**ATTACHMENT VII**

**COMMENTS AND RESPONSES ON THE  
DRAFT MODELING PROTOCOL IN SUPPORT OF  
A FIVE PERCENT PLAN FOR PM-10  
FOR THE MARICOPA COUNTY NONATTAINMENT AREA,  
PREPARED BY THE MARICOPA ASSOCIATION OF GOVERNMENTS,  
JULY 10, 2006**

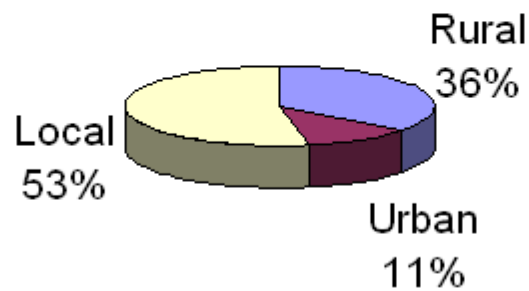
Comment: 1. PM<sub>10</sub> from Outside the Salt River Study Area - Two lines of experimental evidence, as well as anecdotal observations and the general failure to meet PM<sub>10</sub> standards in the Salt River Study Area despite enhanced dust-control regulations and compliance efforts, suggest that an appreciable fraction of elevated PM<sub>10</sub> concentrations originates from outside the area. Speciated fine and coarse PM concentrations have been analyzed to calculate the percentage of “foreign” PM. This would appear to be about 45%. The calculations are explained in the first table, and are presented in the second.

The second line of evidence, described in the “Technical Support Document for the Revised PM<sub>10</sub> State Implementation Plan for the Salt River Area”, June 2005, page 5-24, is based on continuous PM<sub>10</sub> monitoring at West 43<sup>rd</sup> Ave and at two sites east and west of the study area. The percentage of “boundary” PM<sub>10</sub> from this work is about 50% (46.9 to 50.8% for four design dates), in agreement with the “foreign” PM estimated from the speciated measurements.

Response: We appreciate the time and effort that ADEQ has expended to analyze the PM-10 problem in the Salt River Area. The information provided by ADEQ, along with monitoring to be performed in the fall of 2006 for the MAG PM-10 Source Attribution and Deposition Study, will be useful in quantifying the rural background, urban transport, and local components of PM-10 that will be used in modeling attainment in the Salt River Study Area.

**PM on Two High Wind Days: Local, Urban, Rural**

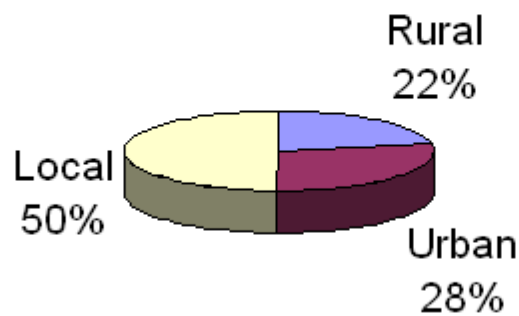
concentrations from local emissions, from urban transport, and from rural background is shown in the figures below. Note that under high wind conditions, the rural contribution is considerably higher than under low wind conditions, consistent with widespread elevated dust levels in a regional wind storm. The protocol needs to describe how the rural background and boundary concentrations will be determined.

If these estimates are taken at their face value, then any modeling analyses of the area, based primarily on dispersion model estimates of the study area emissions, ought to include some means to account for both the rural background and the influx of urban emissions. The only two ways to accomplish this are with a regional, grid-based model or with independent calculations, such as those above, based on monitoring. The protocol should address this issue and explain how this will be done.
